NUCLEAR FUEL SERVICES, INC.
a subsidiary of The Babcock & Wilcox Company

Subject: Revision to Chapter 1, General Information, of License SNM-124

Attachment: SNM-124, Chapter 1, Revision 3, dated October 24, 2014

**SPECIAL NUCLEAR MATERIAL LICENSE
SNM-124**

**Figure 1A-1
NFS Corporate Structure**

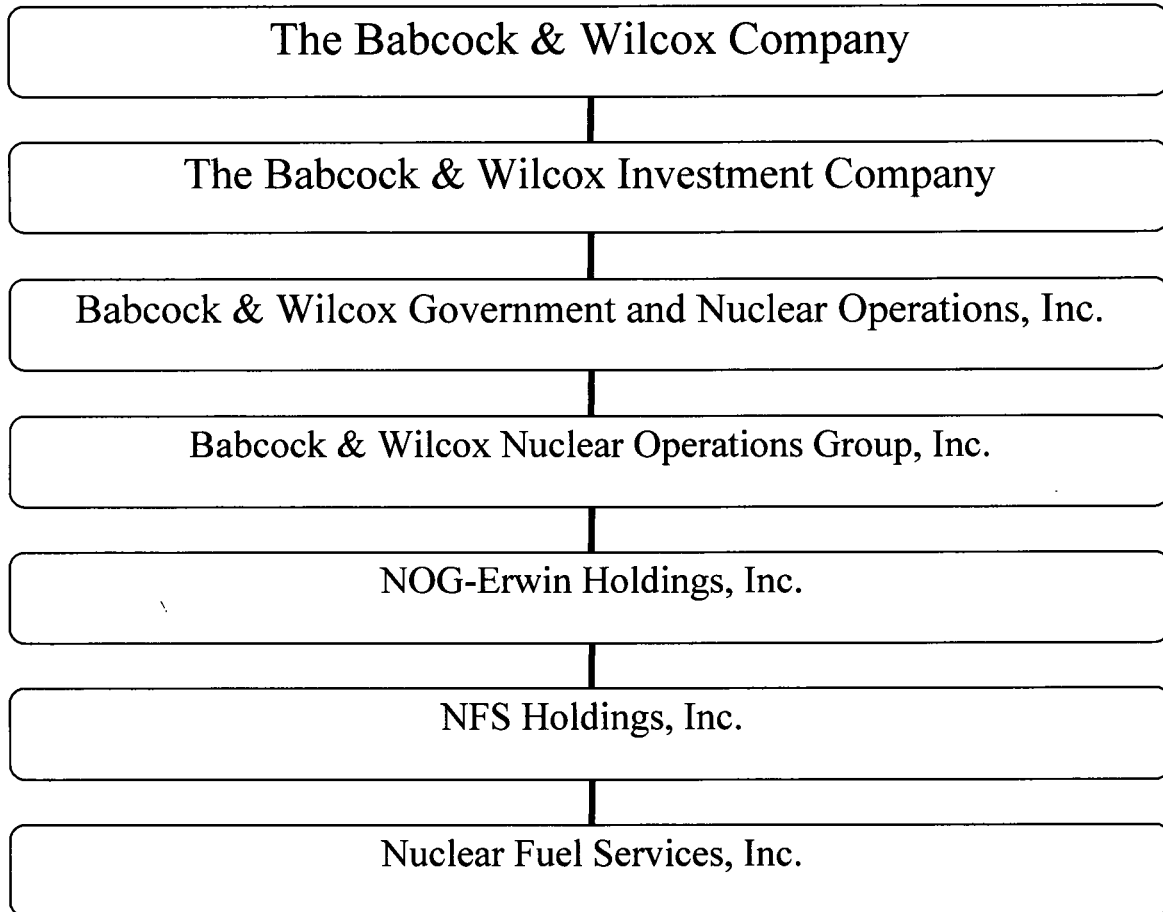
In Reference 2, the Commission determined that changing the name from BWX Technologies, Inc. to Babcock and Wilcox Government and Nuclear Operations, Inc., is not a direct or indirect transfer of control under applicable NRC Regulations. Therefore, making this change to Chapter 1 meets the criteria of License Condition (LC) S-2 and does not require prior NRC approval. A few additional changes to Chapter 1, that also meet the criteria of LC S-2, are included in this submittal: updating the "Protected Area" definition and correcting its description throughout the chapter due to security barrier changes; updating the site facility acreage; updating the support facilities descriptions to reflect relocation of the shipping/receiving staging area for non-nuclear materials from Building 350 to the new warehouse Building 250; updating the Maintenance Facilities to include Building 300B; updating the license period to 25 years, with an expiration date of August 31, 2037; correcting the location of the posting authorized in Section 1.2.5.2; clarifying that the "equivalent experience" definition applies throughout the license for organizational positions that have specific educational requirements; and updating the demographics and meteorology information; and correcting the NFS description on Appendix 1A.
